**MEMPHIS AND SHELBY COUNTY OFFICE OF PLANNING AND DEVELOPMENT  
STAFF REPORT #**

**CASE NUMBER:** BOA 14-20      **B.O.A. MEETING:** June 25, 2014

**DEVELOPMENT NAME:** 3664 Spottswood BOA

**LOCATION:** 3664 Spottswood Avenue

# Aerial of Site

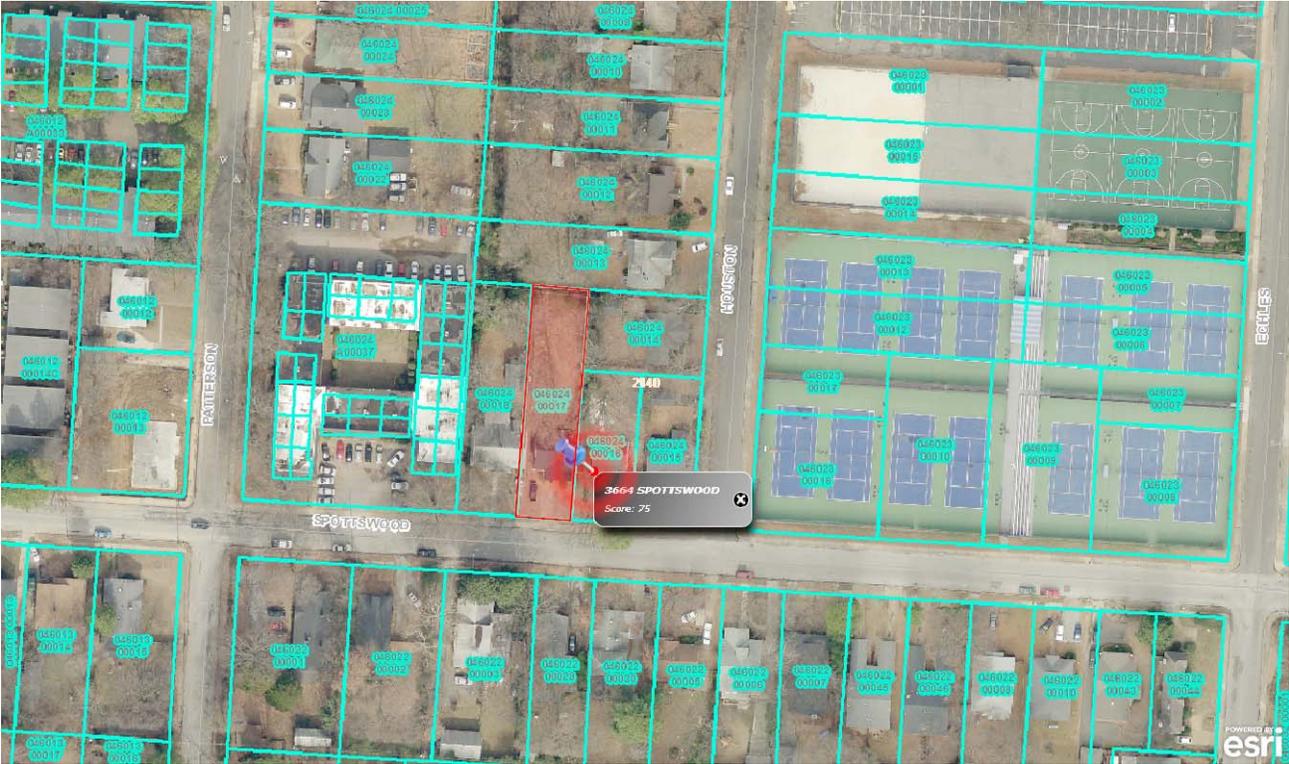
The subject site has frontage along Spottswood.
